#### **HEARINGS COMMITTEE UPDATED AGENDA**

#### 1 RESOURCE CONSENT APPLICATION – LUC-2023-36, 12 ANNIE STREET, OSBORNE

Report

Figure 2: drone image with labels showing 2022 earthworks

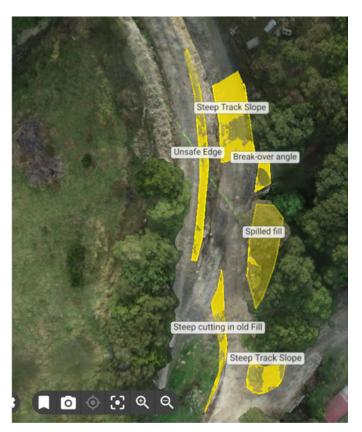
- [17] On 1 June 2022, a complaint (COM-2022-66) was lodged with Council for unconsented earthworks that had been undertaken within 12 Annie Street as well as within the Bradley Road and Annie Street road reserves. The unconsented earthworks created a new access way to the east of the original access way within 12 Annie Street. Council's consultant engineer, Stantec New Zealand Ltd (Stantec) visited the site in June 2022 as part of the compliance investigation. During that visit, they flew a drone to help identify areas of concern, which were labelled in the drone image shown in Figure 2.

A -A' LONG SECTION

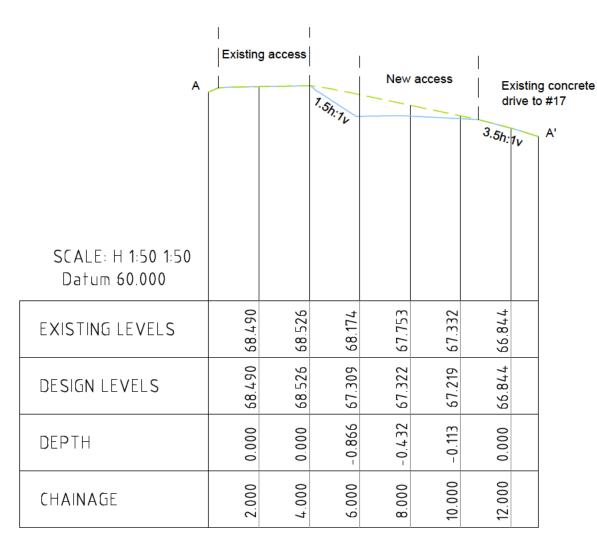
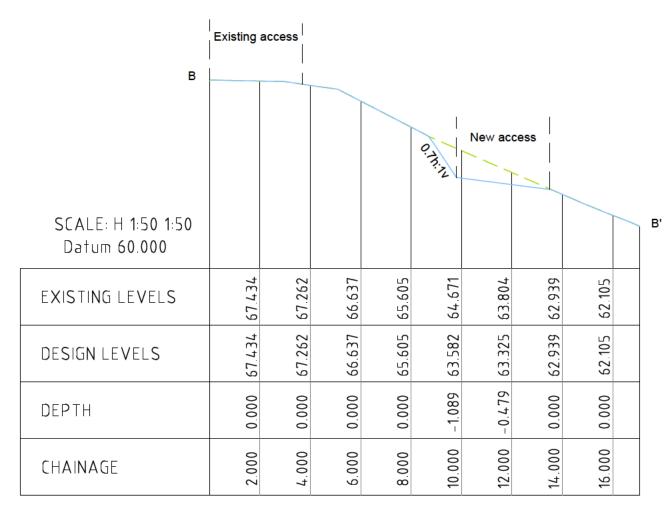
The applicant has now confirmed that he will not be doing any retaining structure. He will only batter as shown on the site plan. He has not provided a cross section of the proposed batter.
